**DODDRIDGE COUNTY COMMISSION
DODDRIDGE COUNTY, WEST VIRGINIA**

**DODDRIDGE COUNTY ADMINISTRATIVE ANNEX
WEST UNION, WEST VIRGINIA
THRASHER PROJECT #060-0981**

**ADDENDUM #3
APRIL 1, 2021**

ADDENDUM REFERENCE / NUMBER
ADD 3
SK1.01

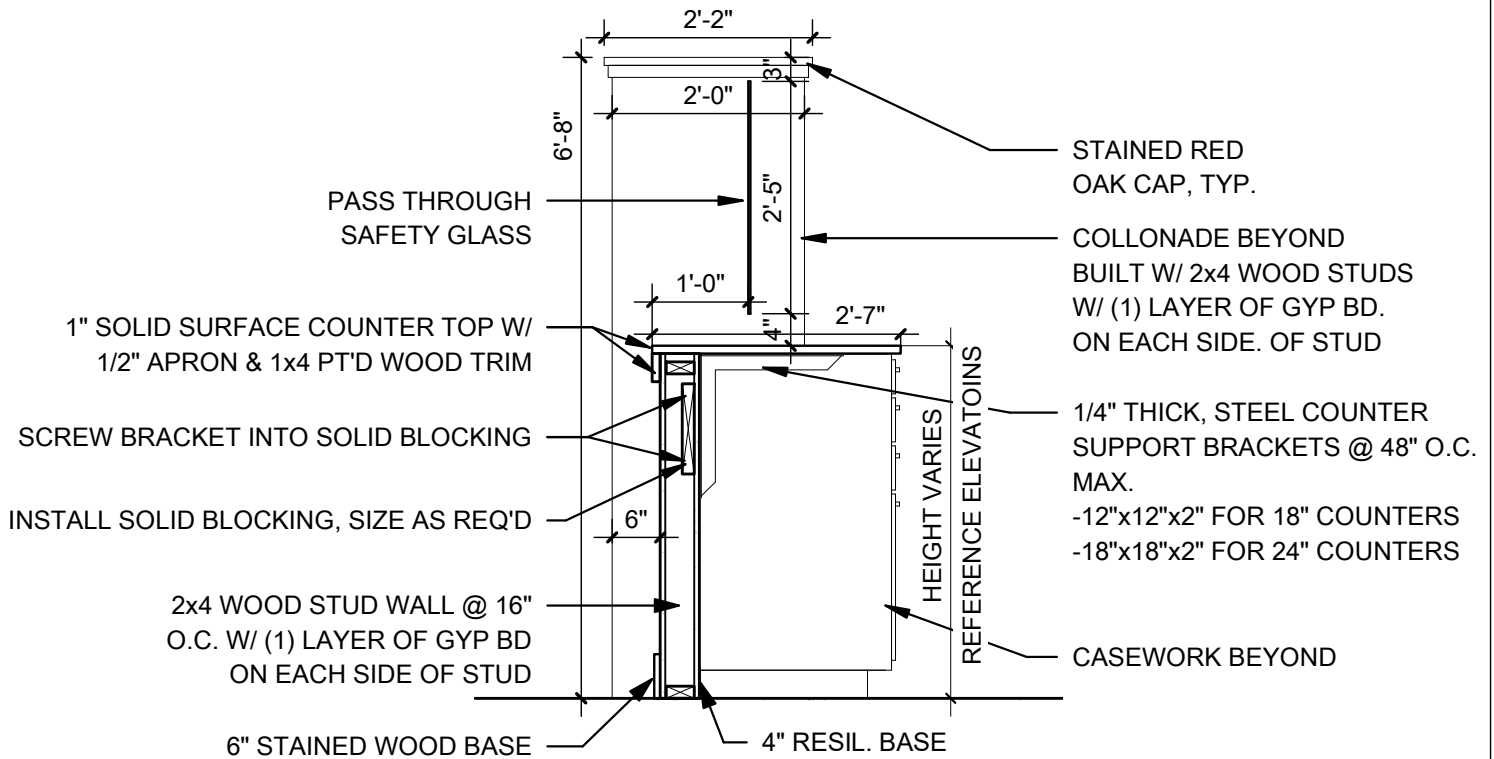
Q17: Women's 210 and Men's 211 seem to show a countertop and at sinks. Elevations on A4.02 show wall hung sinks. Which is correct.

A17: There should be a countertop & sink (L-1) in rooms 210 & 211 as well as 110 & 111. See SK1 attached to this addendum.

1 CASEWORK SECTION @ RM 233 & 236
 1/2" = 1'-0"

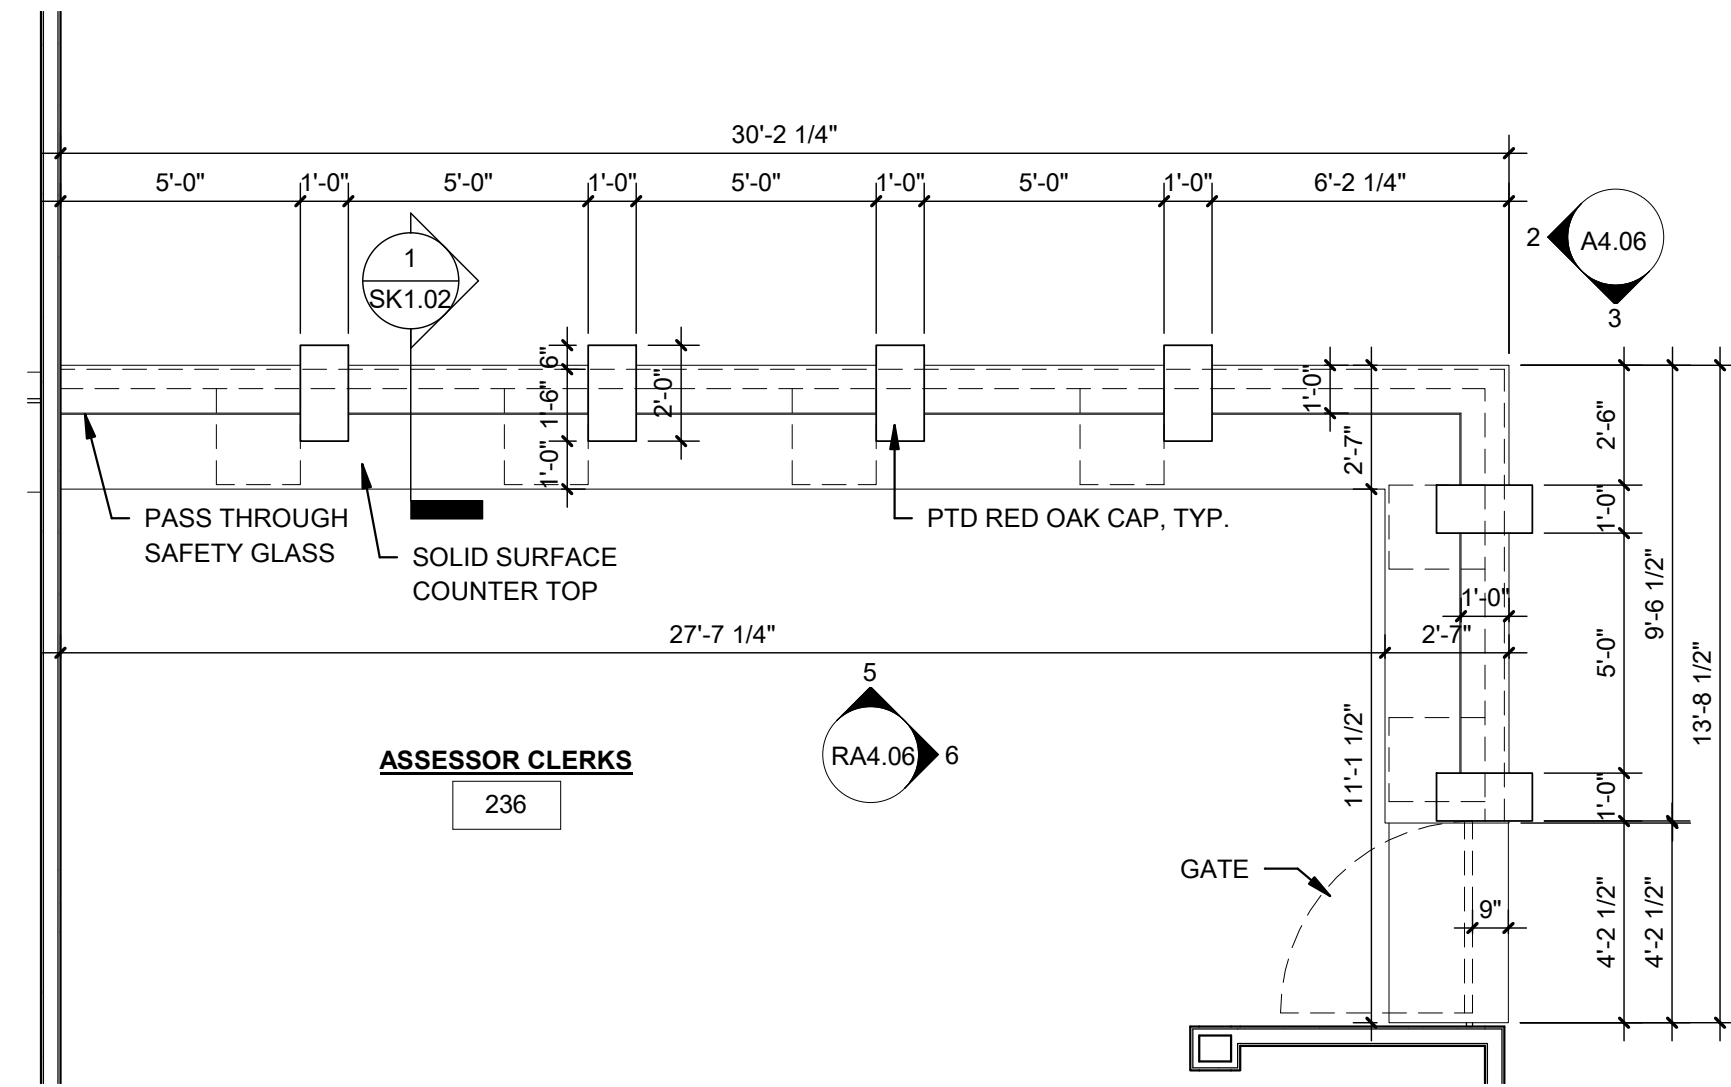
Q15: Can we get a wall section through the case work at rooms 233 and 236.

A15: See SK2 attached to this addendum.

9 TYPICAL SCREEN SHIELD

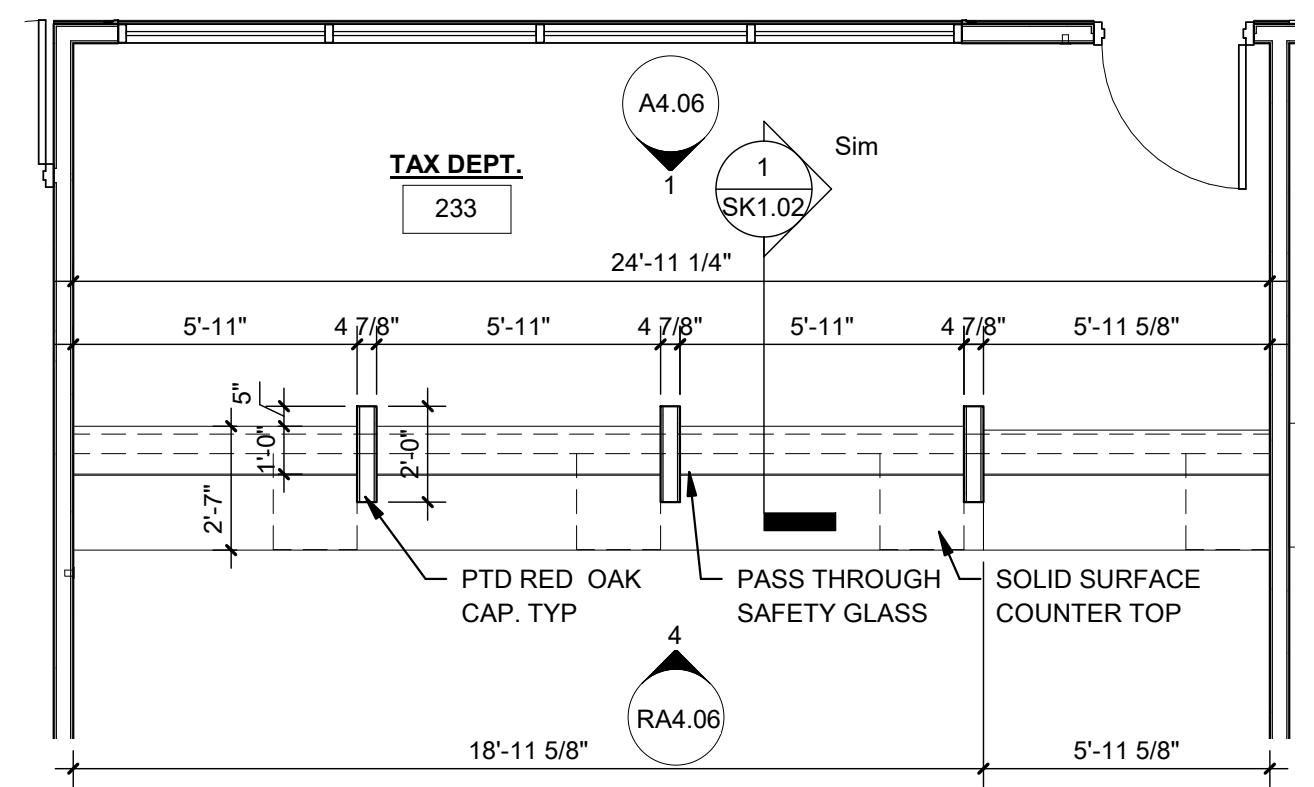
- Q1: Detail 7/A4.06 illustrates the glass screen making a 90 degree corner. This is not possible without the existence of a corner support post. Please advise.
- A1: The plan would be to butt joint polished edge 1/4" safety glass. A clear sealant could be added if needed for stability.

SKM-1

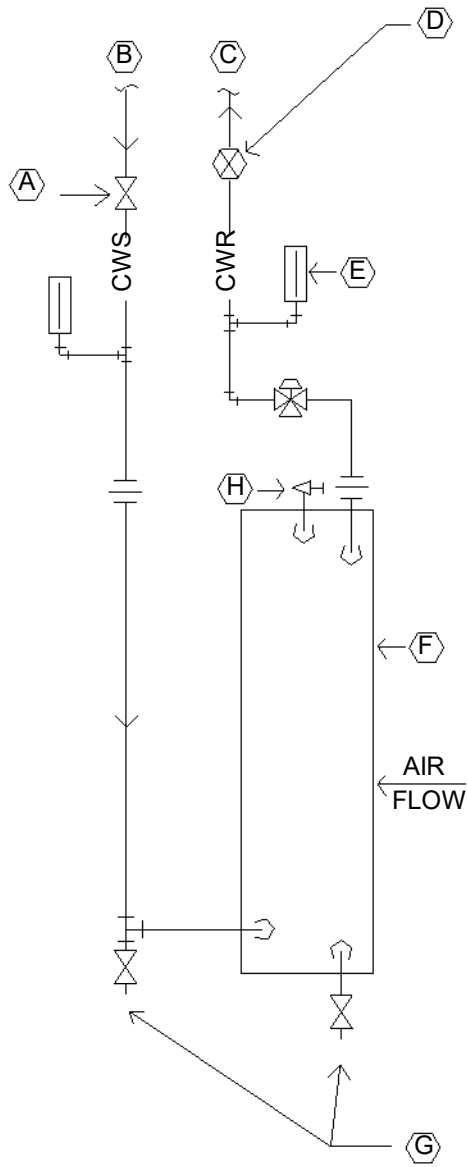
- A8: Provide fire dampers where ductwork passes thru floor.
- Q9: Please provide a VAV coil connection detail showing all components required?
- A9: See SKM-1

- (A) GATE OR BALL VALVE (TYPICAL)
- (B) SUPPLY
- (C) RETURN
- (D) CIRCUIT SETTER
- (E) THERMOMETER (TYPICAL)
- (F) COOLING COIL
- (G) 3/4" HOSE END DRAIN VALVE
- (H) MAV=MANUAL AIR VENT
